Product End-of-Life (EOL) Notification

AFFECTED PART NUMBER(S): LLNS-1T06-x LLNF-1T06-x LLFL-1T06-x		EOL No. <p style="text-align: center;">22</p>
PART DESCRIPTION: LZ4 Narrow Spot TIR Lens LZ4 Narrow Flood TIR Lens LZ4 Flood TIR Lens		DATE: <p style="text-align: center;">7/6/2015</p>
RECOMMENDED REPLACEMENT PART NUMBER(S):		
<i>Affected P/Ns</i>	<i>Replacement P/Ns</i>	<i>Description of Replacement Part</i>
LLNS-1T06-x	LLNS-2T06-x	<i>Form, fit and function compatible with the affected P/Ns, but note that:</i> 1. Inner light pipe diameter increased from 6.9mm (in affected P/Ns) to 7.9mm (in replacement P/Ns). See next page for details. 2. Performance comparison table is on next page.
LLNF-1T06-x	LLNF-2T06-x	
LLFL-1T06-x	LLFL-2T06-x	
REASON FOR EOL: Transitioning to set of lenses with larger inner light pipe diameter to ease pick and place in large scale fixture assembly.		
LAST ORDER DATE: LED Engin will continue to accept order for the affected parts until inventory is depleted		LAST SHIPMENT DATE: <p style="text-align: center;">N/A</p>

LLxx-1T06-x (Affected P/Ns)

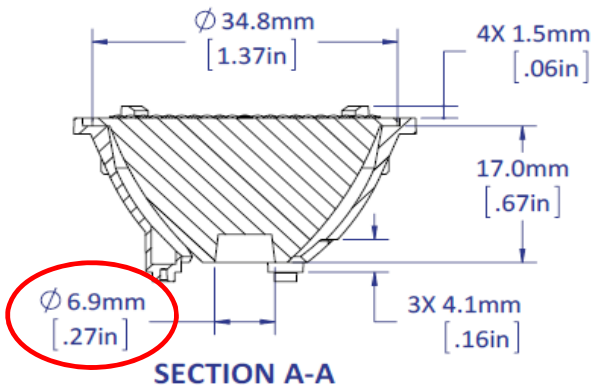
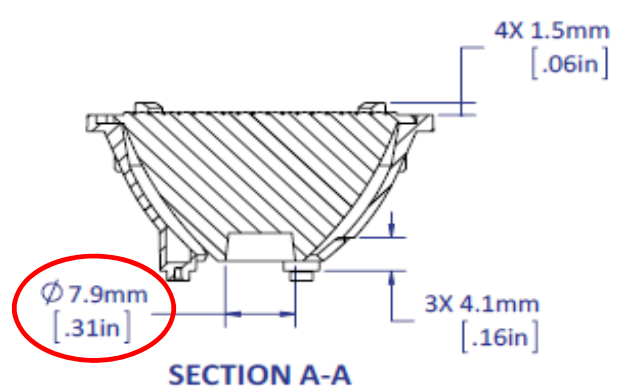
Part Number	Beam Angle (deg)	On-axis Intensity (cd/lm)
LLNS-1T06-x	14	7.9
LLNS-2T06-x	14	8.8
LLNF-1T06-x	22	3.0
LLNF-2T06-x	25	2.9
LLFL-1T06-x	40	1.6
LLFL-2T06-x	37	1.6
